50 ATKINS RD., FUQUAY VARINA, NC.

NEW ATTIC BATHROOM & CLOSET

FLOOR PLAN, ELEVATIONS, SECTION

DRAWING NUMBER A-1

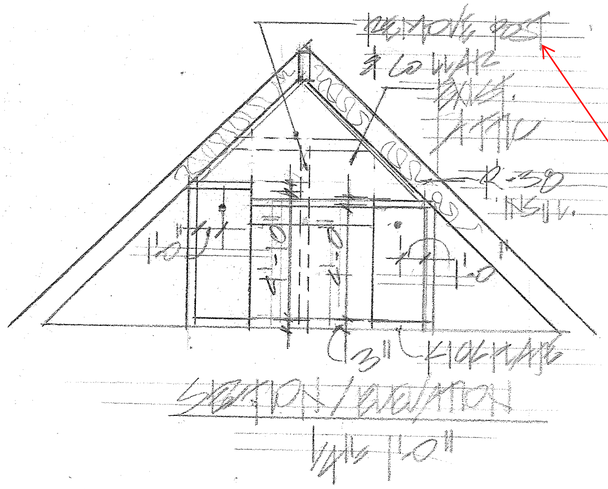
If this is a structural support post, it may not be removed without another way to support roof point load.
